WELL API NO. 30-005-20006	
5. Indicate Type of Lease STATE ☒ FEE ☐	
6. State Oil & Gas Lease No.	
7. Lease Name or Unit Agreement Name Cato San Andres Unit	
8. Well Number #33	
9. OGRID Number 248802	
10. Pool name or Wildcat Cato; San Andres

**Proposed P&A NOI
State of NM Orphan Well Program
Cato San Andres Unit #33
30-025-20006**

**Cato San Andres Unit 33
BLM
March 25, 2025
Conditions of Approval**

State of NM Formerly Cano Petro of NM			PROPOSED	
Author:	Abby @ JMR		Well No.	#33
Well Name	Cato San Andres Unit		API #:	42-005-20006
Field/Pool	Cato; San Andres		Location:	Sec 9, T8S, R30E
County	Chaves			1980 FNL & 660 FEL
State	NM		GL:	4128
Spud Date	12/30/1966

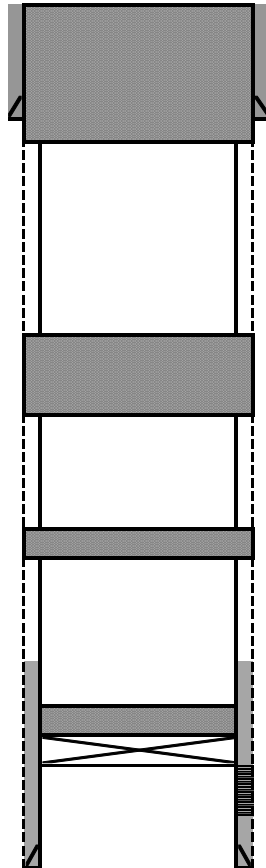
1. Operator shall place CIBP at 3,162 ' (50'-100' above top most perf) and place a minimum of 50 sx of Class C cement on top to isolate the top of the San Andres Formation. WOC and TAG a minimum of 2,505'.

2. Operator shall perf at 2,181' and squeeze Class C cement to 2,018' seal the Grayburg and Queen Formations. WOC and TAG.
3. Operator shall perf at 1,475' and squeeze Class C cement to 1,320' seal the Yates and bottom of the Salt Formations. WOC and TAG.

4. Operator shall perf at 1,118' and squeeze Class C cement to 900' seal the top of Salt and Rustler Formations. WOC and TAG.
5. Operator shall perf at 561' and squeeze class c cement to surface to seal the 8-5/8" casing shoe.

6. Dry hole marker must be below ground.
7. Surface reclamation will need to be completed once the well bore has been plugged. Please contact rflores@blm.gov for additional information.
